Access Compliance Report

Public Rights-of-Way

Intersection ID: 52490	Main Street: WHITEHALL EXECUTIVE CENTER DR	Cross Street: PRAGUE LN	Location: W
ADA ID: 09BA1231F85A	Ramp Type: Perp	Initial Pass/Fail: Pass	Overall Compliance: No
Codes/Mitigation Info/Possible Solution		Field Measurements/Component Compliance	
Severity Score: 2.75

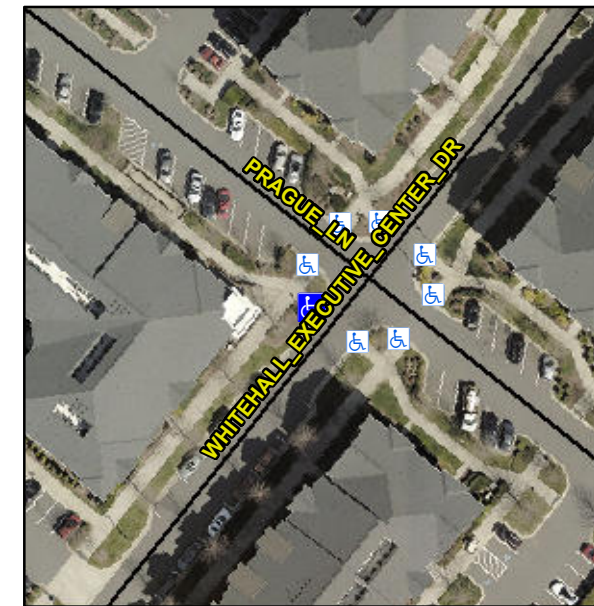
Not Found, R304.5.3, R305.1.4, R302.7

Compliance	Description	Data	Compliance	Description	Data
N/A	Ramp Length (in)	77.0	Yes	Ramp Slope (%)	5.9
Yes	Ramp Width (in)	71.0	No	Ramp XSlope (%)	2.1
Yes	Flare Type L	Curbed_NoWalkSurface	Yes	Flare Type RT	N/A
Yes	Flare Slope LT (%)	N/A	N/A	Flare Slope RT (%)	N/A
N/A	Flare Traversable LT?	No	N/A	Flare Traversable RT?	No
Yes	Landing Length (in)	72.0	Yes	DWS Provided?	Yes
Yes	Landing Width (in)	72.0	Yes	DWS Contrast?	Yes
Yes	Landing Slope (%)	0.1	Yes	DWS Length (in)	24.0
Yes	Landing X Slope (%)	1.0	No	DWS Full Width?	No
N/A	Landing Curb? (Y/N)	No	Yes	DWS Offset (in)	0.0
N/A	Shared Landing?	No			
No	Gutter Ponding?	Yes	Yes	Gutter Slope (%)	1.0
Yes	Gutter Lip Ht (in)	0.0	Yes	Gutter X Slope (%)	0.4
N/A	Painted X Walk1?	No	N/A	Painted X Walk2?	N/A
	X Walk 1 Direction	To SE		X Walk 2 Direction	N/A
N/A	X Walk 1 Width (in)	N/A	N/A	X Walk 2 Width (in)	N/A
	X Walk 1 Slope (%)	1.2		X Walk 2 Slope (%)	N/A
	X Walk 1 X Slope (%)	0.8		X Walk 2 X Slope (%)	N/A

Remove & Replace Entire Ramp.
